MITIGATION PLAN

SWAMP GRAPE STREAM AND WETLAND MITIGATION SITE

Response to IRT Comments

Swamp Grape Mitigation Site (DMS ID No. 100115)
Contract No. 0007869
Lumber River Basin 03040204, Robeson County
USACE AID#: SAW-2019-01732
NCDMS #: 100115
IRT Reviewers: Travis Wilson (WRC), Todd Bowers (EPA),

Scale: AS SHOWN	FIGURE NO. 9
Date: Mar 2020	
Project No.: 20-003

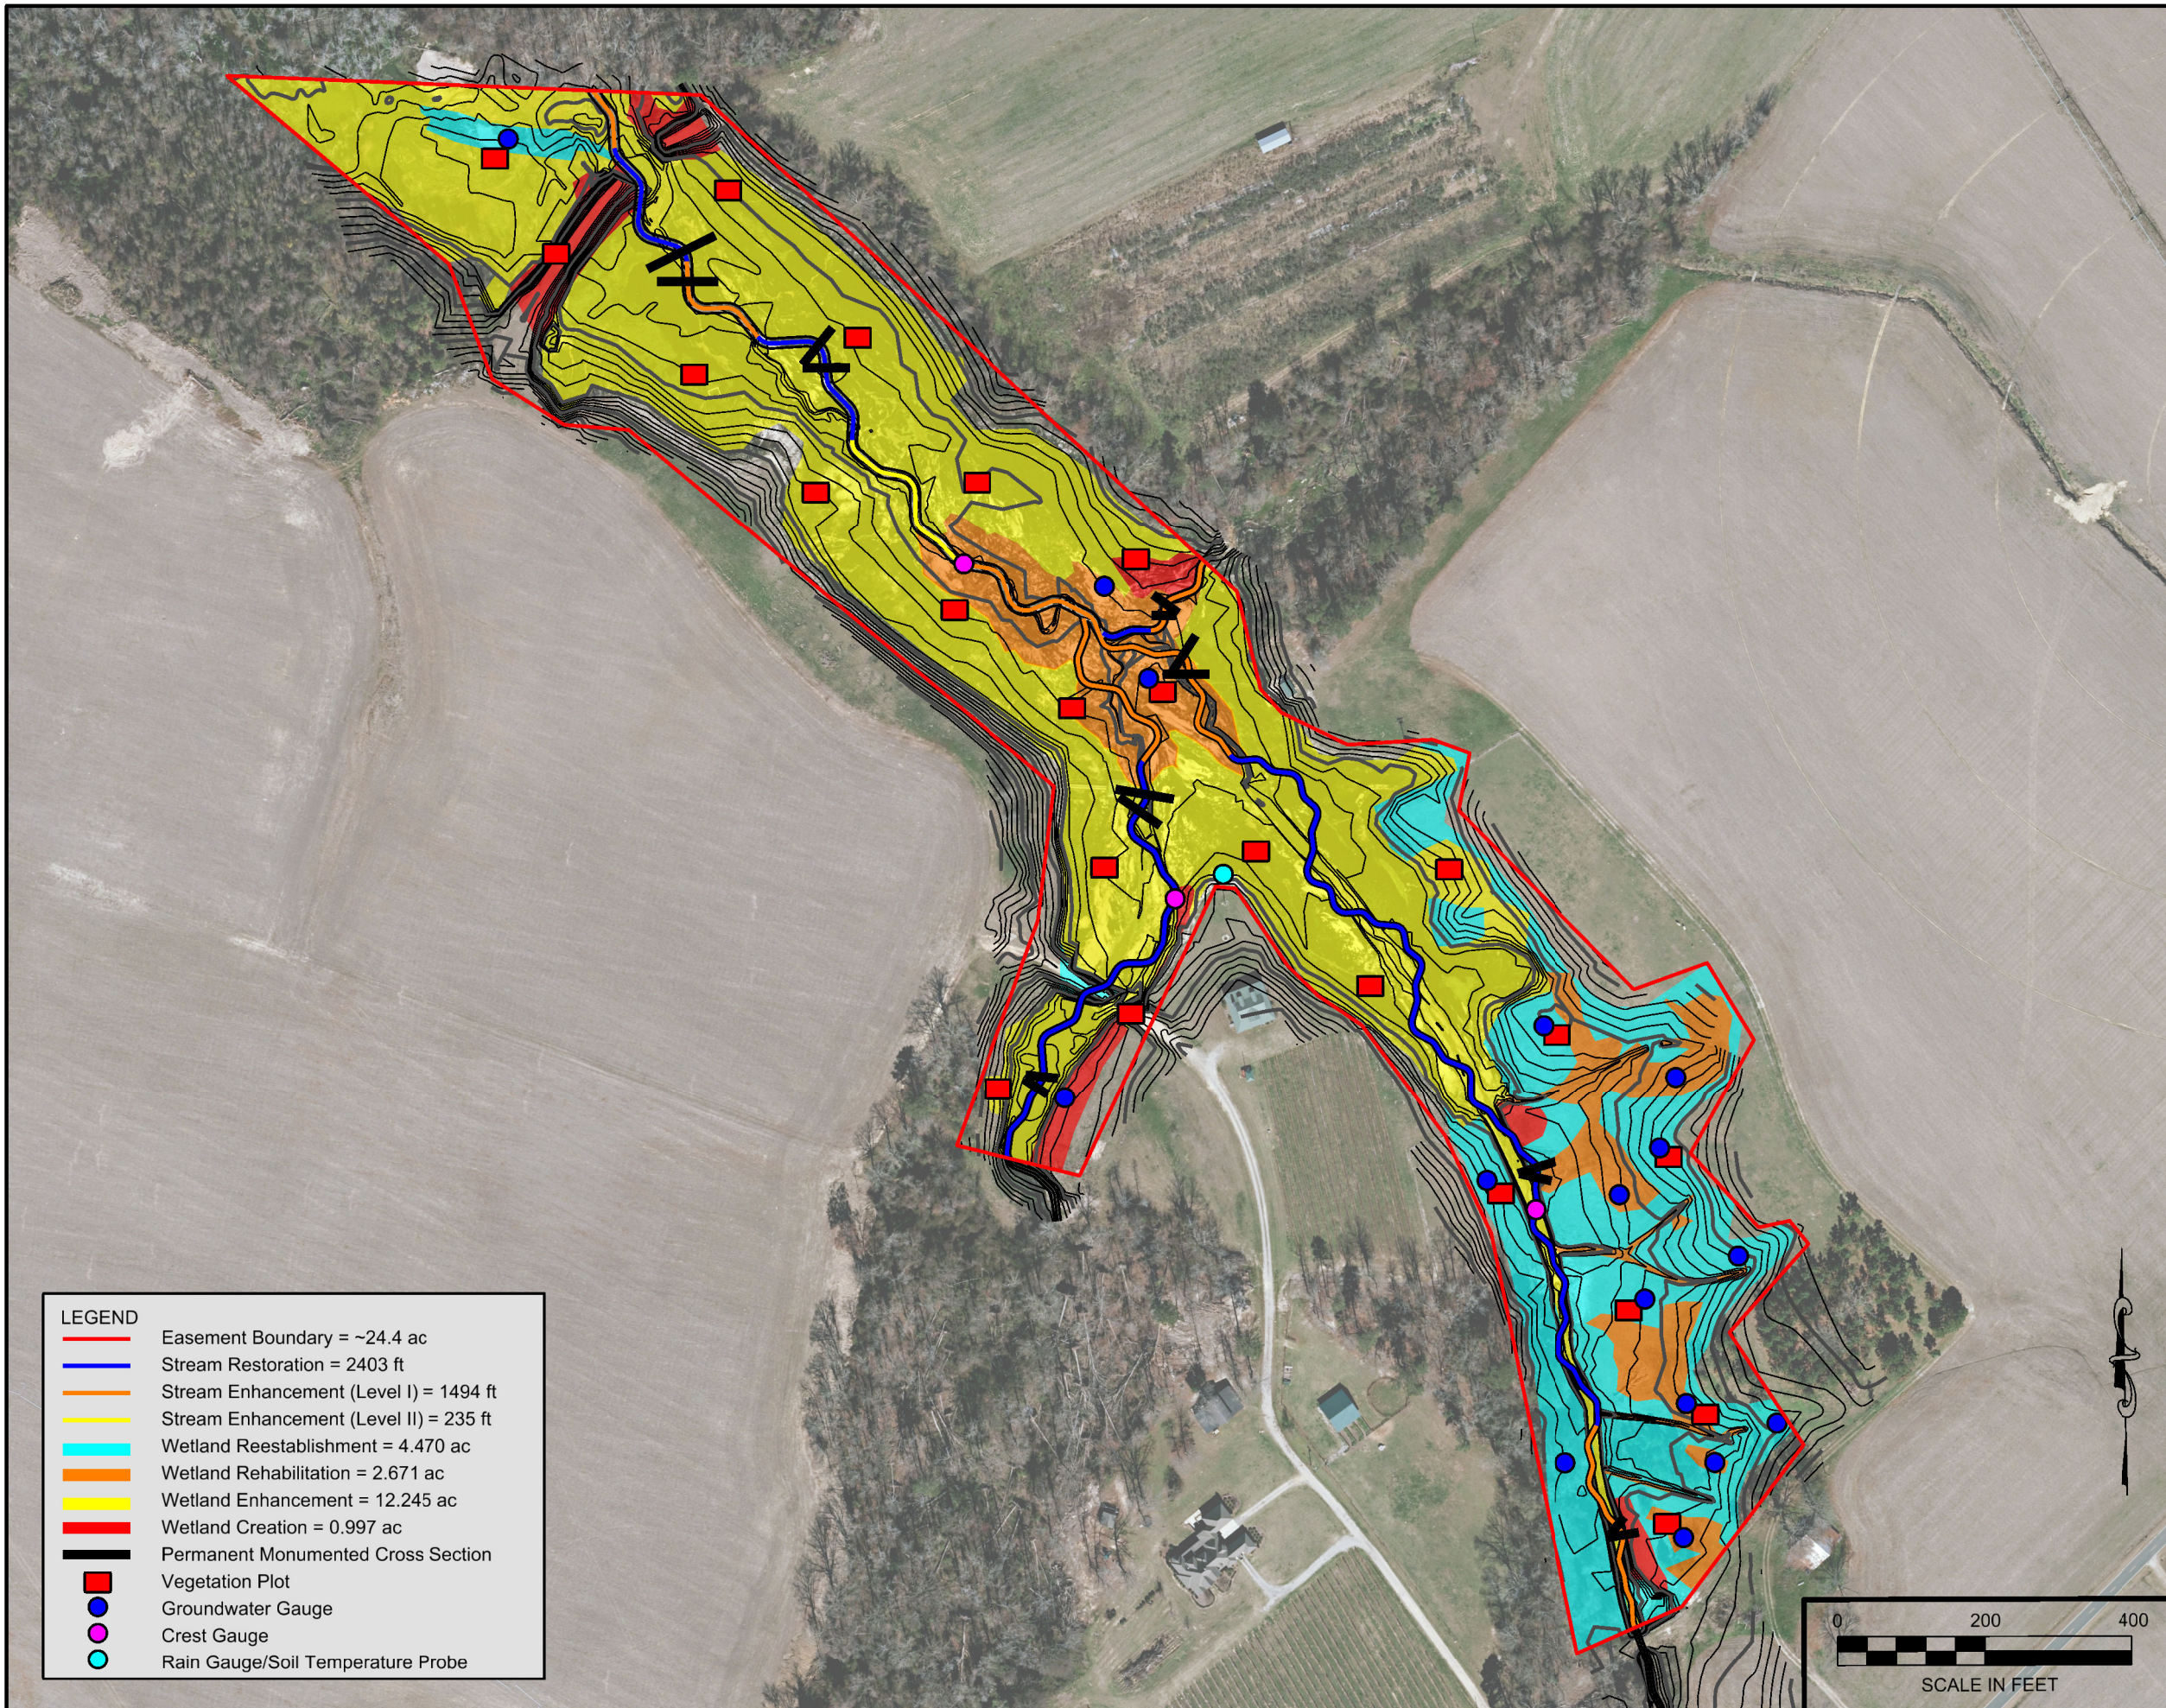
2. Section 4.3/Page 17: Freshwater marsh areas, those expected to be dominated by an open herbaceous community, are not depicted in Figure 9 (Appendix A).
Construction is anticipated to be completed in the summer of 2021, observations after construction and into the winter of 2021/2022, will allow for targeted planting within these communities. Freshwater marsh communities will be identified on CCPVs in annual monitoring reports to calculate percent of Site coverage.

- c. The general location of the herbaceous dominated wetlands are not depicted in Figure 9 (Appendix A). Construction is anticipated to be completed in the summer of 2021, observations after construction and into the winter of 2021/2022 will allow for targeted planting within these communities. Freshwater marsh communities will be identified on CCPVs in annual monitoring reports to calculate percent of Site coverage.

9. Figure 9/Appendix A:

- a. Recommend adding the vegetation monitoring plots to the planting zone map to ensure each zone is monitored. The inclusion of the veg plots in Figure 10 is good to ensure the all wetland mitigation approaches/treatments are monitored.

- b. Table in Figure 9 should be corrected to either increase the density of the streamside assemblage or the footnote should be 680 stems/acre. See previous statement 4.d.

Vegetation Plots have been added to Figure 9.

The planting table has been updated on Figure 9 and in the text of the document.

Scale: AS SHOWN	FIGURE NO. 10
Date: Mar 2020	
Project No.: 20-003

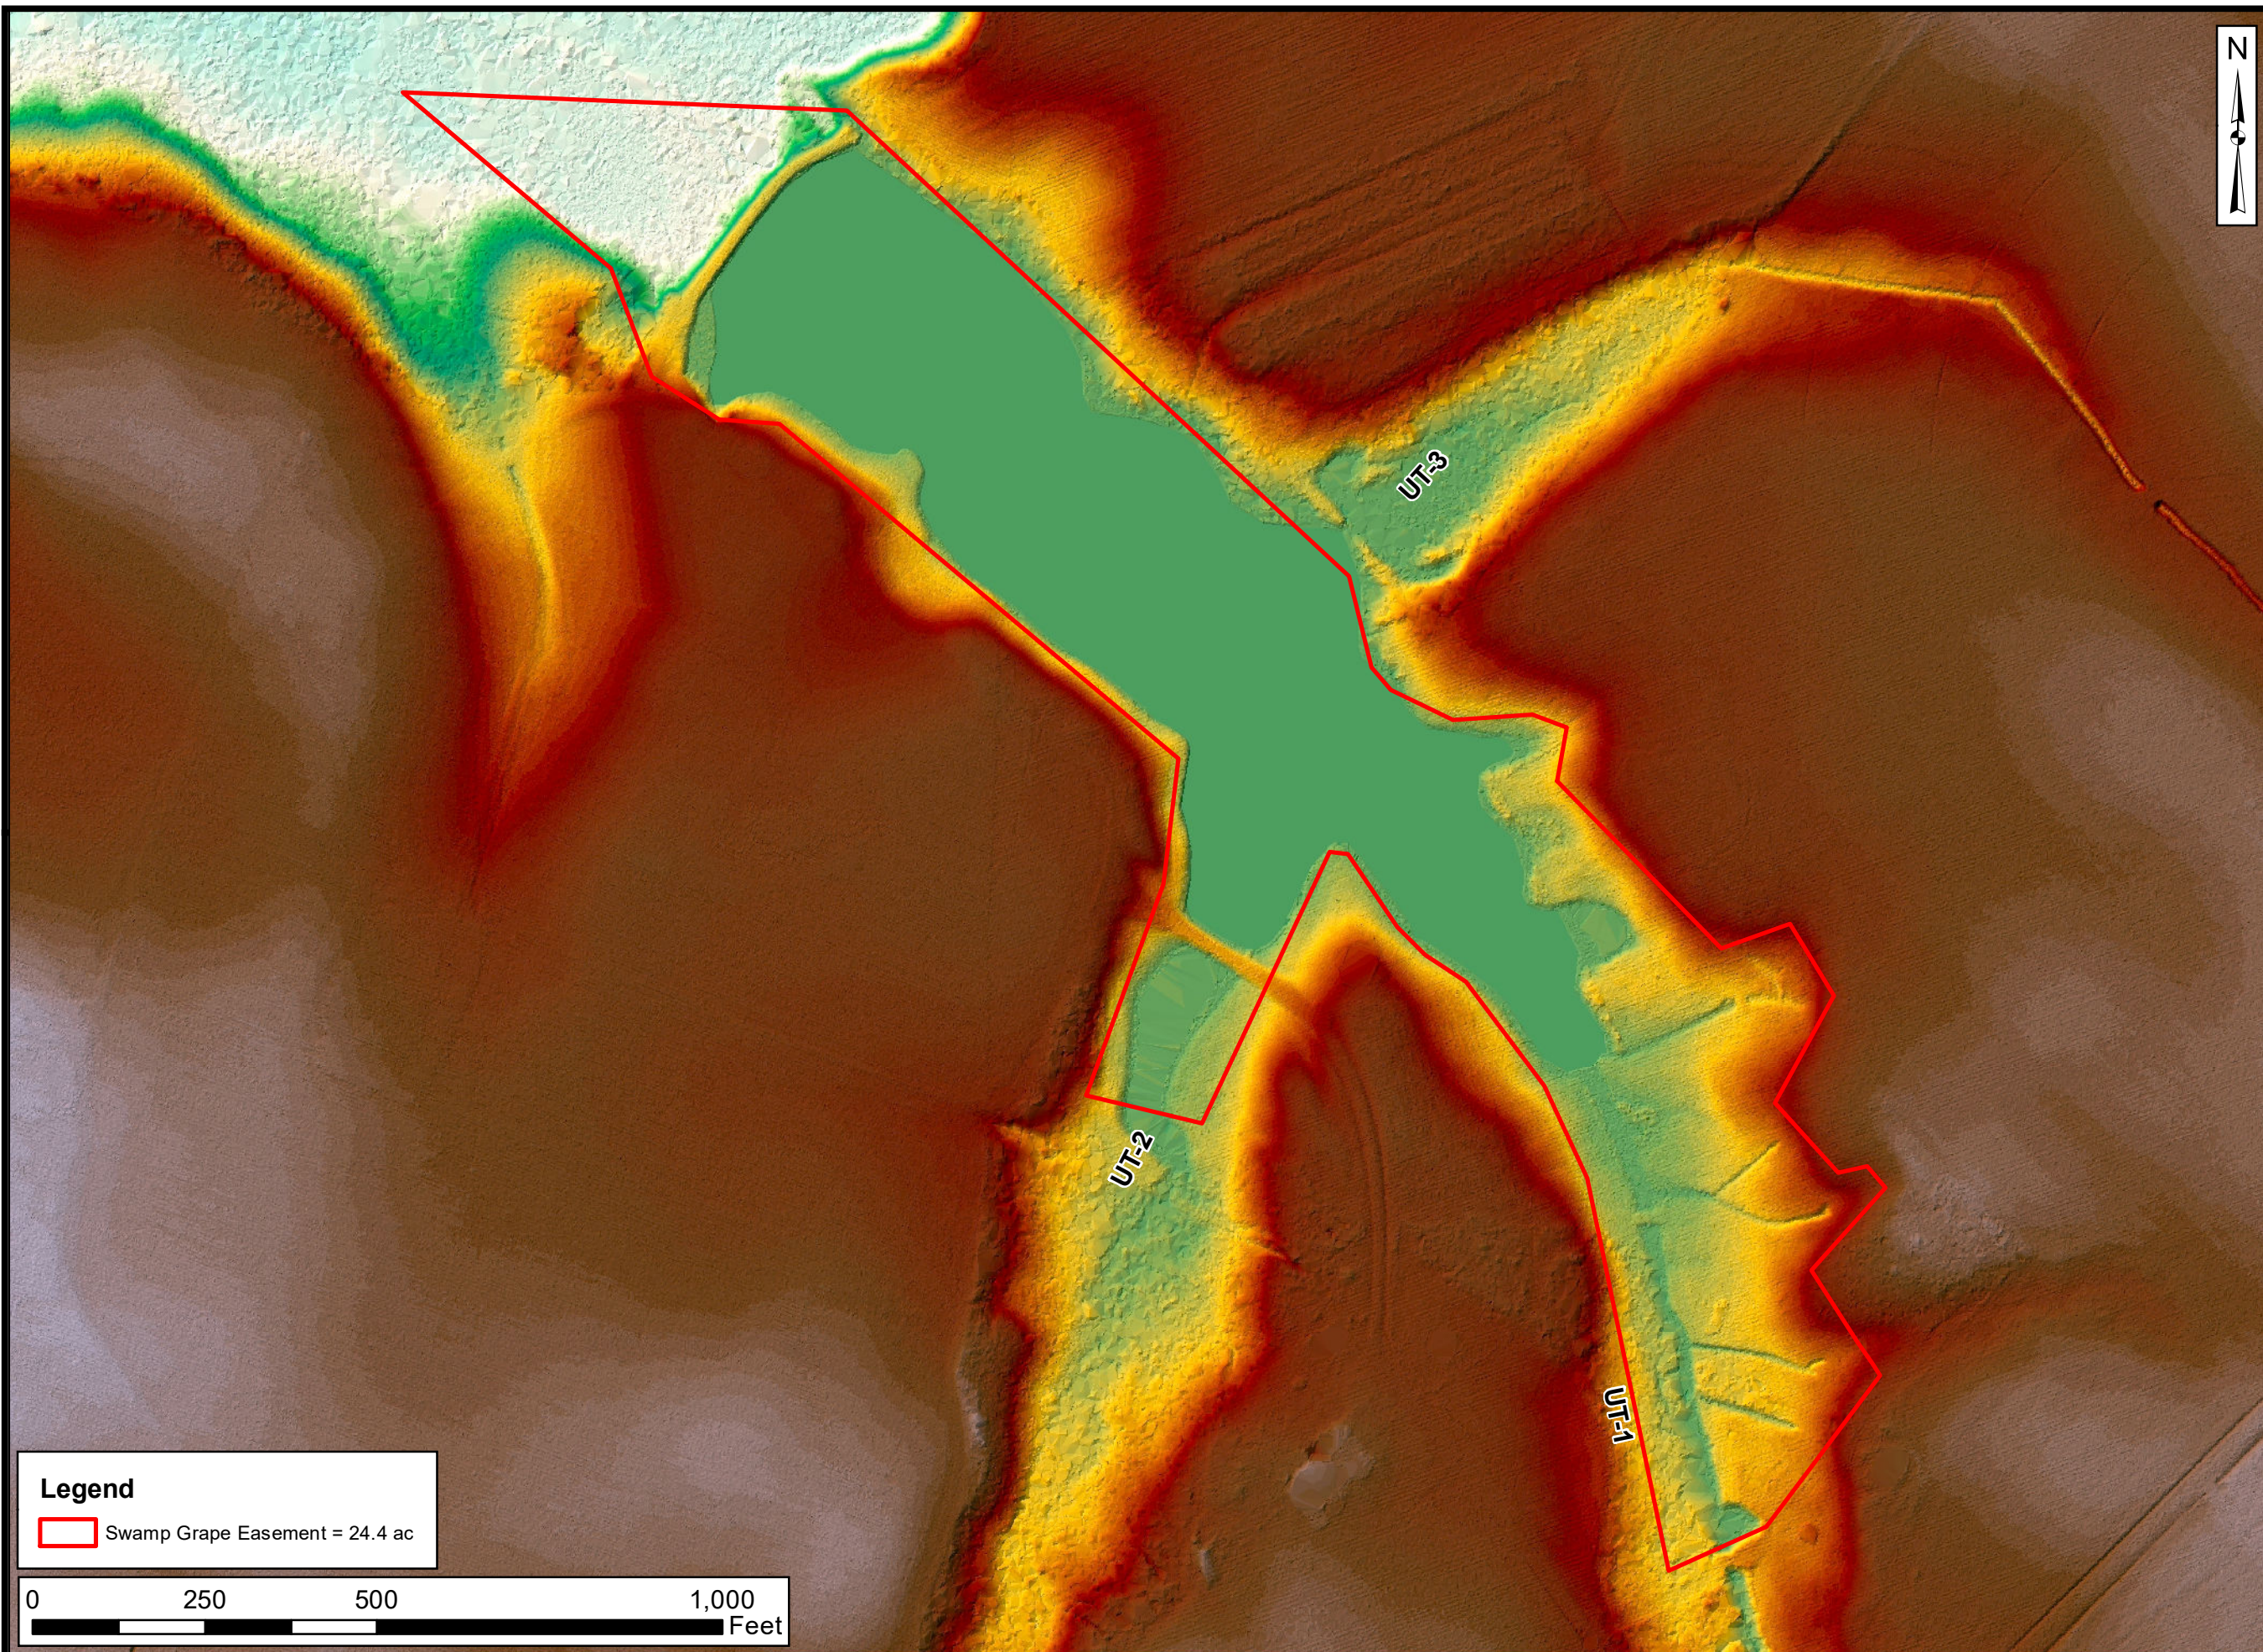
16. Figure 10 – DWR requests three of the groundwater gauges be placed near the upland edge of the proposed wetland reestablishment/rehabilitation areas along UT1, since this is the area DWR is most concerned with meeting the minimum hydroperiod performance standard.
Two gauges were moved towards the upland boundary and a third was added near the upland boundary in along UT1 reestablishment/rehabilitation areas.

C5.07

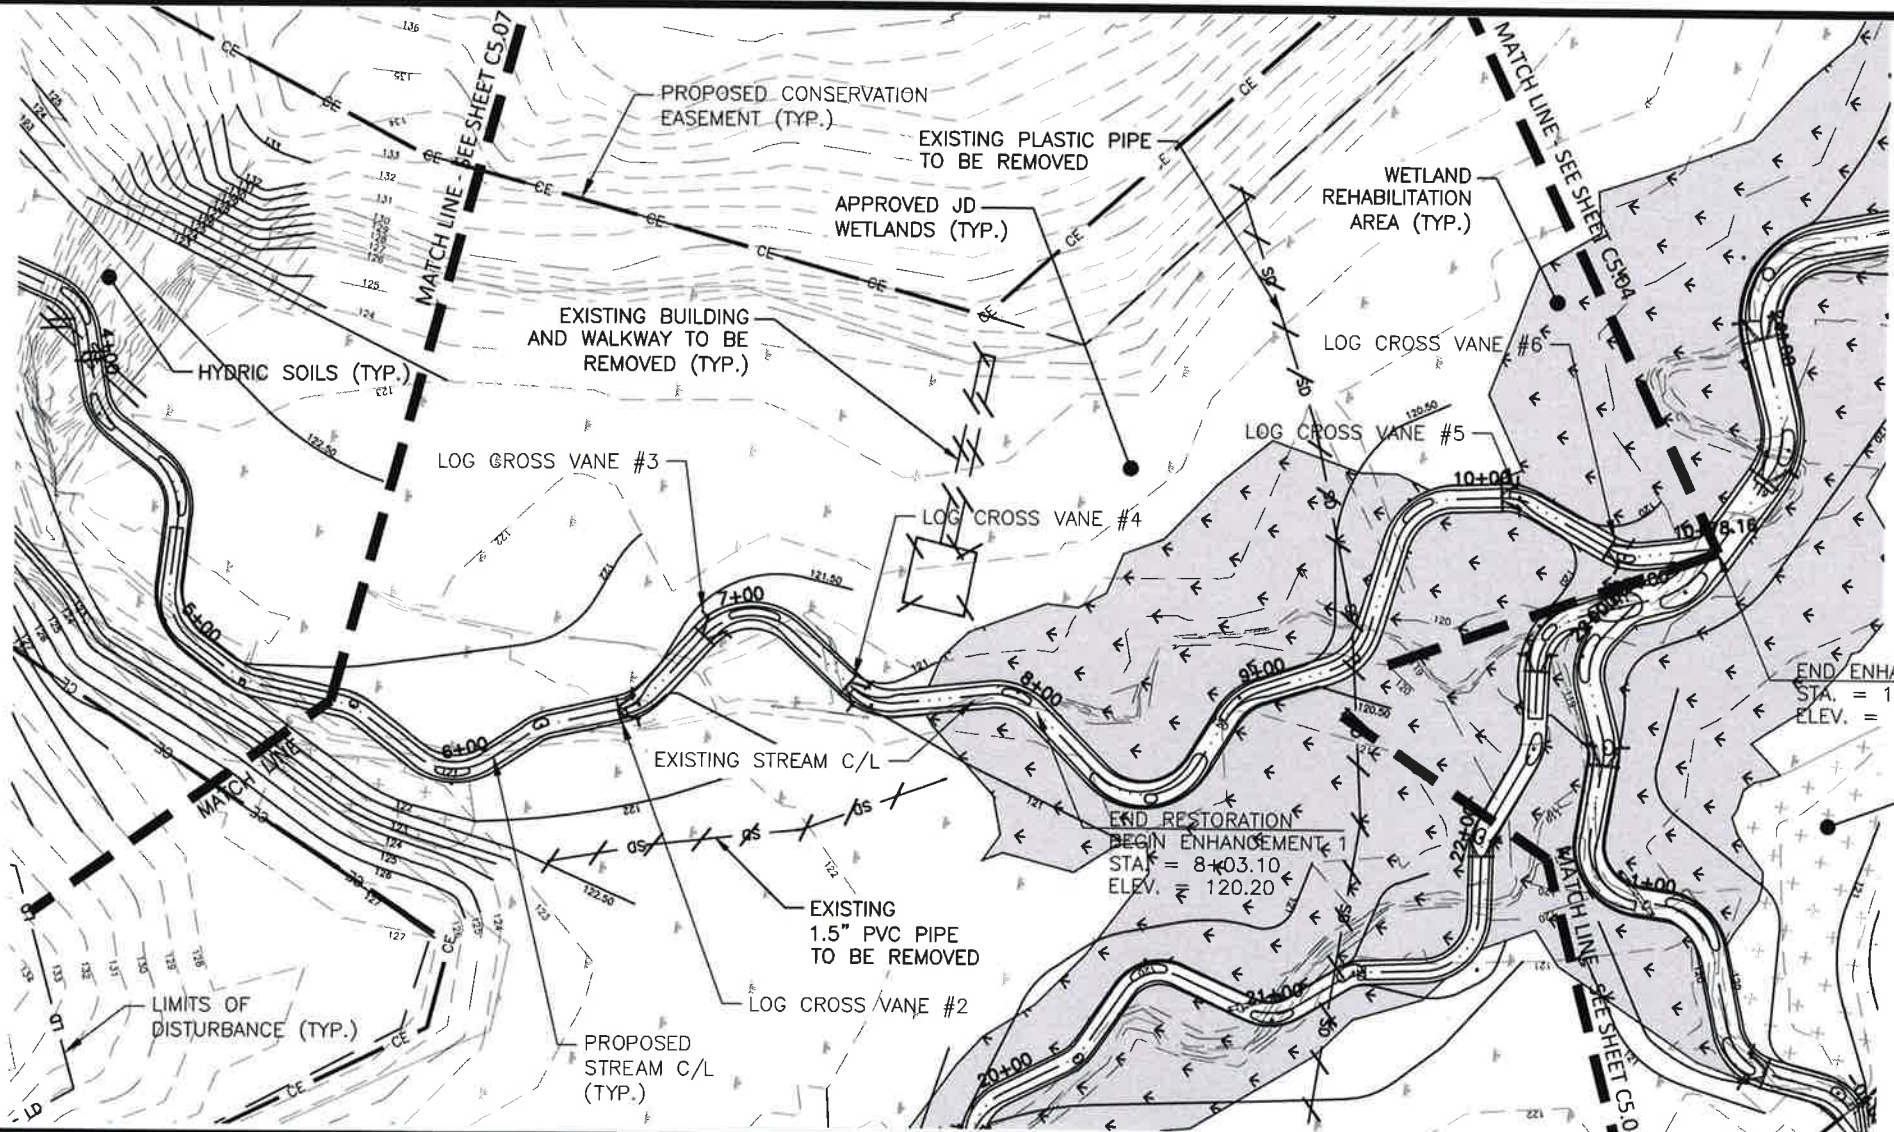
19. Appendix K – Please include a copy of the May 2019 IRT site visit meeting minutes.
The May 2019 meeting minutes have been included in Appendix K.
20. Sheet C5.07 – Why is the UT2 restoration stream segment near station 5+00 located at the toe of a steep slope near the CE boundary? What prohibits this segment from being restored within the center of the valley and CE?
Topographic mapping and ground truthing indicate that the lowest portion of the floodplain is on the right bank valley edge. This is where the current channel is flowing.
